REVISED Decision Table C. Other Height Requests

Contents of Decision Packet C: Other Height Requests

SUBJECT: Attachment for Decision Table C: Recommended Amendments to Proposed Draft 33.510.210 Height

Map C1: Old Town / Chinatown Heights

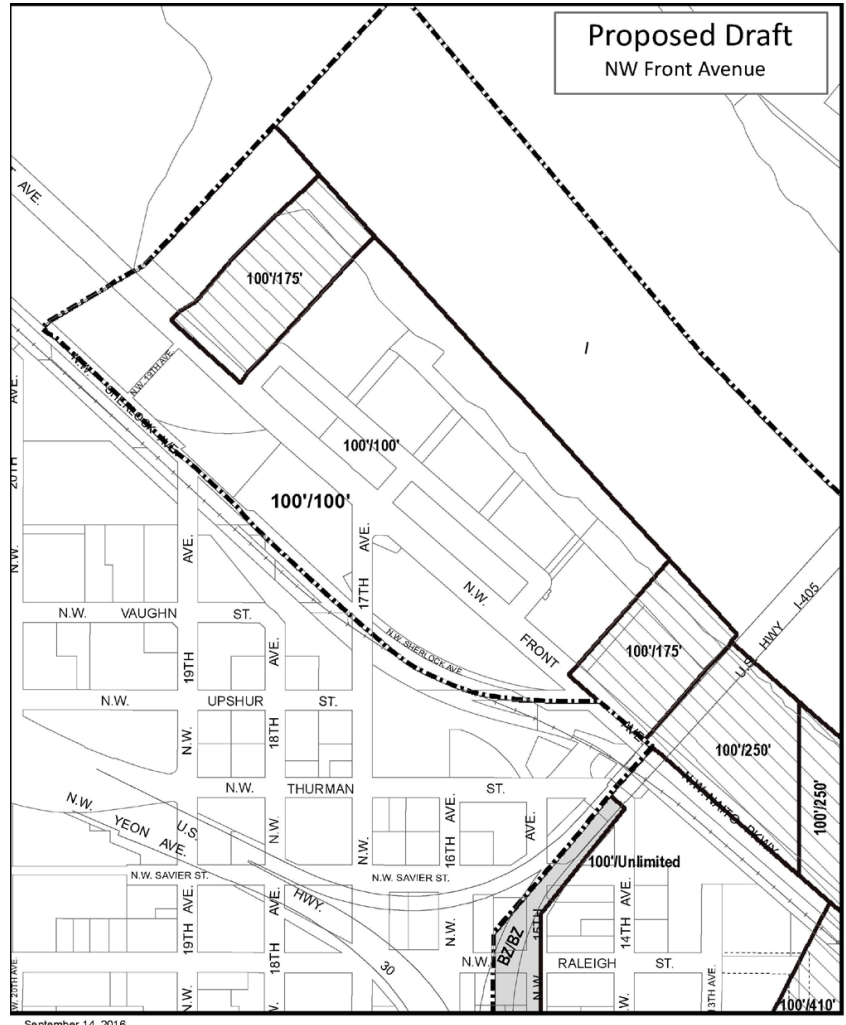
Ref #	Comment #	Commenter(s)	District	Proposed draft	Request(s)	Staff recommendation	Staff rationale	Discuss?	PSC decision
C1 and Map C1	20332, 20429, 20989	Carrie Richter for David Leiken; Carrie Richter David Gold	Old Town/ Chinatown Area: 6 block area between W Burnside and NW Everett and 5th and Broadway	Base Height: 250' Bonus Height: None Reference: Volume 2A Pt. 1: Map 510-3, p. 327.	Base Height: 460' (existing) Bonus Height: None The proposed reduction is not justified and the area to the north can bonus to 325'.	Proposed Amendment: Base Height: 250' (as proposed) Bonus Height: 325' See Map C1	Existing base heights are 460'. Staff recommends lowering base heights to 250' because: <ul style="list-style-type: none"> • The Central City Plan (1988) anticipated that the high-rise downtown commercial core would expand north of Burnside. This has not happened. • Existing developable sites among older buildings are generally smaller and will more likely redevelop to 250'-325' (or lower) similar to other development in the area. This is a pattern staff would like to see preserved. The proposed amendment would continue to propose a base height at 250', but add the potential for 75' of bonus height similar to the properties to the north.	<input type="checkbox"/>	<input type="checkbox"/> Support staff rec. <input type="checkbox"/> Other

Map C2: NW Front Ave Heights

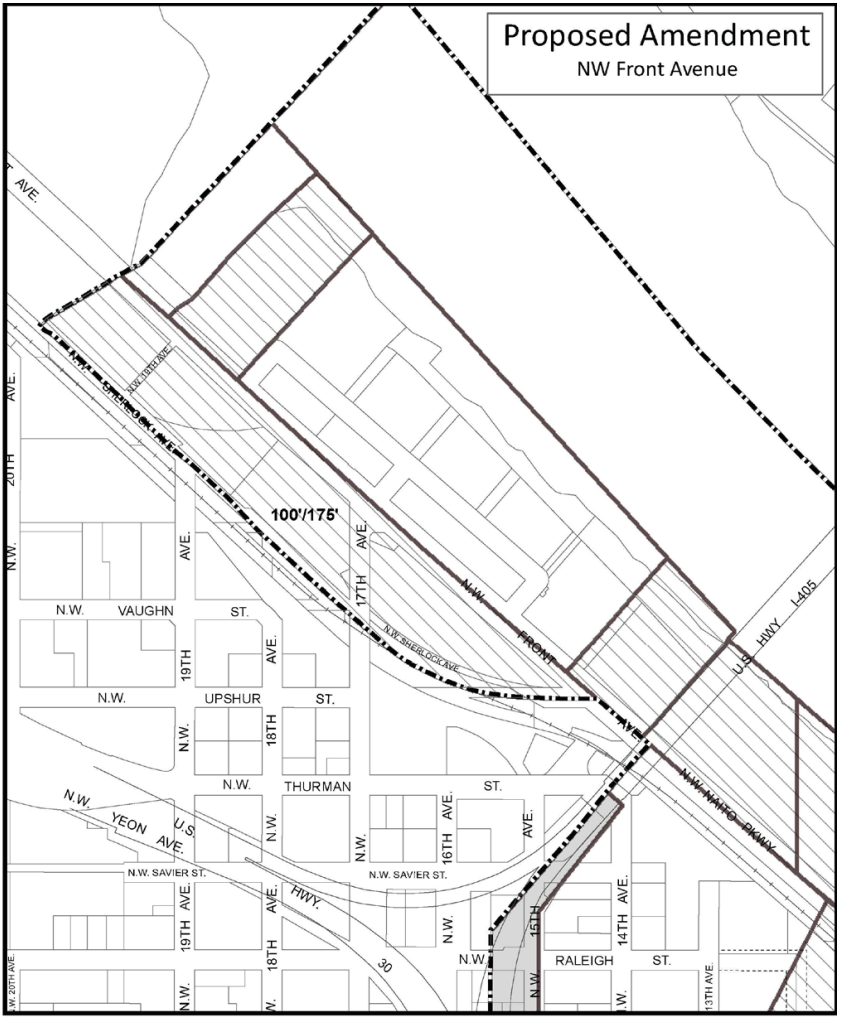
C2 and Map C2	20306	John Southgate LLC; on behalf of Ken Unkeles and Tom Goldsmith	Pearl District Area: West of NW Front in NW corner of Pearl	Base Height: 100' Bonus Height: None Reference: Volume 2A Pt. 1: Map 510-3, p. 326	Base Height: 250' Bonus Height: None Increased FAR and height will allow dense future redevelopment that supports many CC2035 policy goals.	Proposed Amendment: Base Height: 100' (as proposed) Bonus Height: 175' See Map C2	<ul style="list-style-type: none"> • Property is currently zoned IH (EX). Staff has proposed to rezone to EX in conformance with the Comp Plan, with a base height of 100' and 2:1 FAR. • The proposed amendment would allow an additional 75' of bonus height consistent with properties along the river to the northeast and southeast of the site. 	<input type="checkbox"/>	<input type="checkbox"/> Support staff rec. <input type="checkbox"/> Other

Map C3: Riverplace Heights

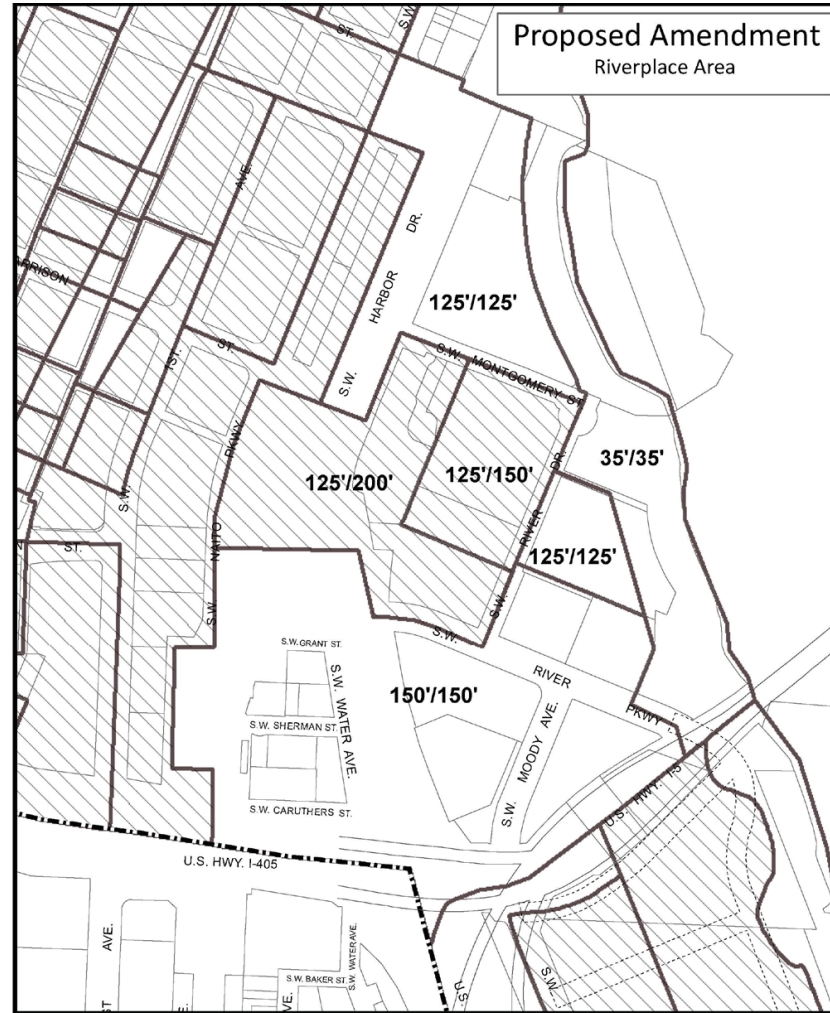
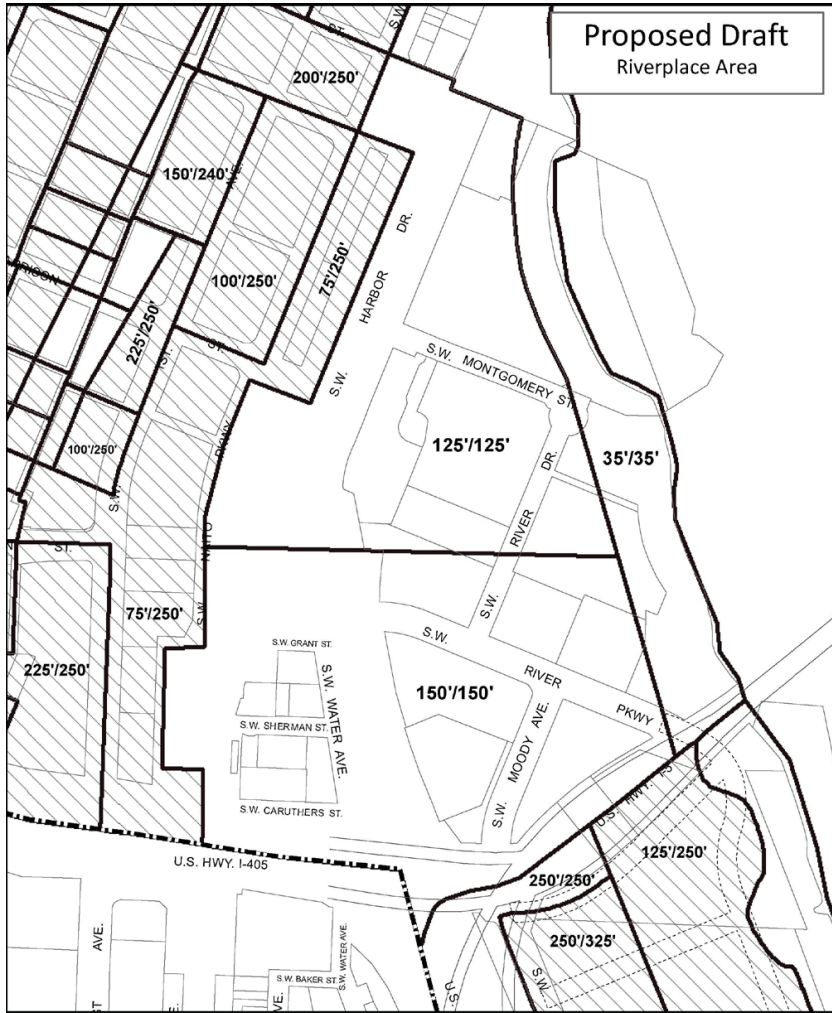
Ref #	Comment #	Commenter(s)	District	Proposed draft	Request(s)	Staff recommendation	Staff rationale	Discuss?	PSC decision
C3 and Map C3	20882, 21032	Augustin Enriquez-GBD Architects Inc. for ABP Capital Augustin Enriquez	University District/South Downtown Area: Portion of RiverPlace	Base Height: 125' and 150' Bonus Height: None (no change from existing). Reference: Volume 2A Pt. 1: Map 510-3. p. 331	Base Height: 250' Bonus Height: None Also rationalize height map line that cuts across property lines and ROW. Increased height will allow redevelopment of site, supporting a vibrant neighborhood.	Proposed Amendment: Base Height: 125' and 150' Bonus Height: 150' and 200' See Map C3	<ul style="list-style-type: none"> As shown on Map C3, staff is proposing to reconfigure the height pattern in this area to align with parcel boundaries and rights of way. Adding the potential for bonus height will encourage denser, urban scale development and more active uses along the riverfront, consistent with the goals of the plan. The staff recommendation retains the step down to the river policy. 	<input checked="" type="checkbox"/>	<input type="checkbox"/> Support staff rec. <input type="checkbox"/> Other

Map C20: Goose Hollow/Uptown Heights

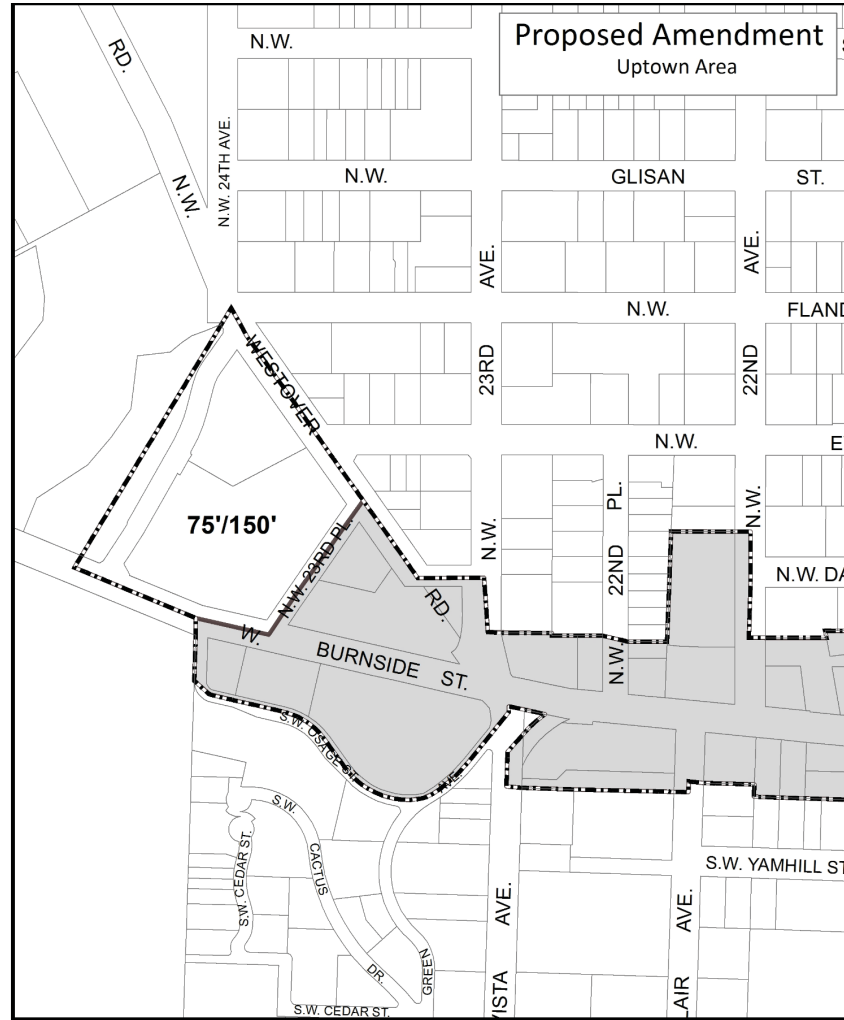
C20 and Map C20	NA	BPS Staff	Goose Hollow Area: Uptown area in NWDA on north side of W Burnside, west of NW 23 rd Place and south of Westover	Base Height: 75' (base zone CX) Bonus Height: None Reference: Volume 2A Pt. 1: Maps 510-3 and 510-4, p. 326-337.		Proposed Amendment: Base Height: 75' (base zone CX) Bonus Height: 150'	Corrects a mapping error. The existing maximum height is 75' with eligibility for 75' of bonus height through the residential FAR bonus (no general height bonus allowed). Eligibility for bonus height was inadvertently removed in the Proposed Draft.	<input type="checkbox"/>	<input type="checkbox"/> Support staff rec. <input type="checkbox"/> Other
-------------------------------	----	-----------	--	---	--	---	---	--------------------------	---

Map C21: Bridgehead Area Heights

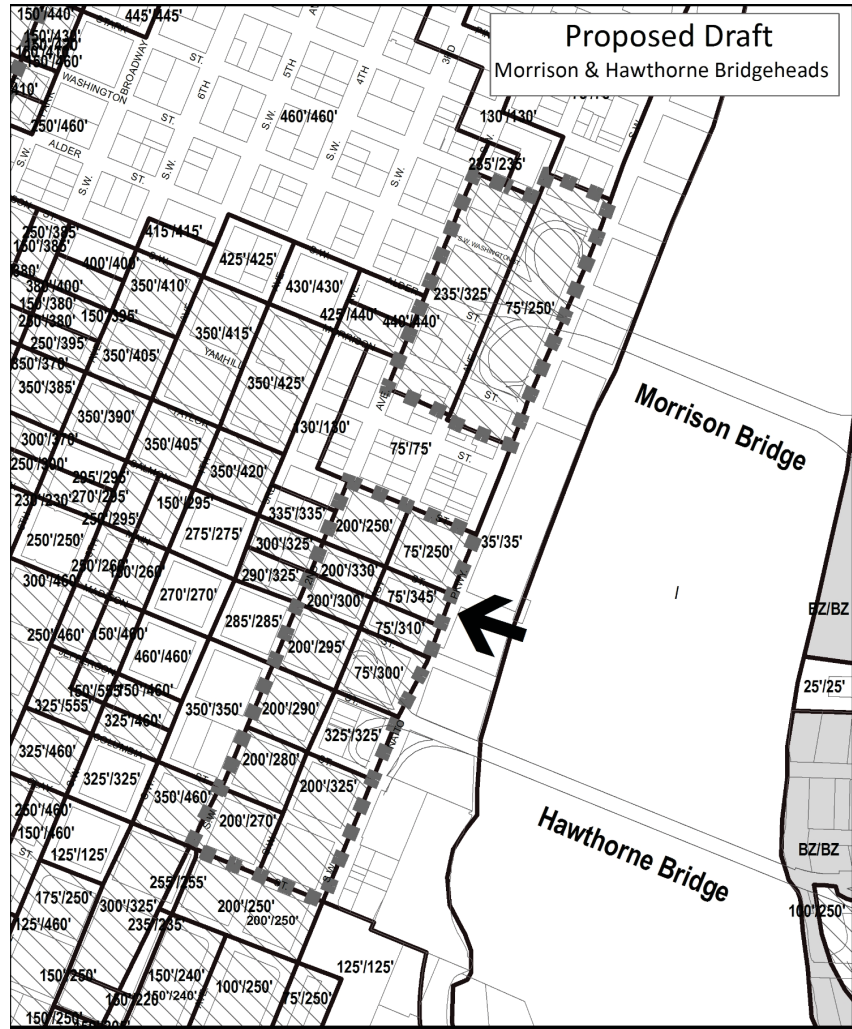
Ref #	Comment #	Commenter(s)	District	Proposed draft	Request(s)	Staff recommendation	Staff rationale	Discuss?	PSC decision
C21 and Map C21	NA	BPS Staff	Downtown Area: Two parcels on south side of SW Salmon in Hawthorne bridgehead area	Base Height: 75’ and 200’ Bonus Height: 345’ and 330’ Reference: Volume 2A Pt. 1: Maps 510-3 and 510-4, p. 326-337.		Proposed Amendment: Base Height: 75’ and 200’ Bonus Height: 325’	Corrects a mapping error. The West Quadrant Plan height concept calls for 325’ maximum height in this area (many are lower due to view corridors). The maximum bonus heights for these parcels were inadvertently set too high in the Proposed Draft.	<input type="checkbox"/>	<input type="checkbox"/> Support staff rec. <input type="checkbox"/> Other
C22	NA	BPS Staff	NA	Map 510-4 (2 Of 3) erroneously shows the boundary of Marquam Hill Plan District. Reference: Volume 2A: Part 1 Central City Plan District, Map 510-4 (2 Of 3), p. 335		Proposed Amendment: Remove boundary of Marquam Hill Plan District from Map 510-4 (2 of 4)	Corrects a mapping error. This plan district is outside the Central City.	<input type="checkbox"/>	<input type="checkbox"/> Support staff rec. <input type="checkbox"/> Other
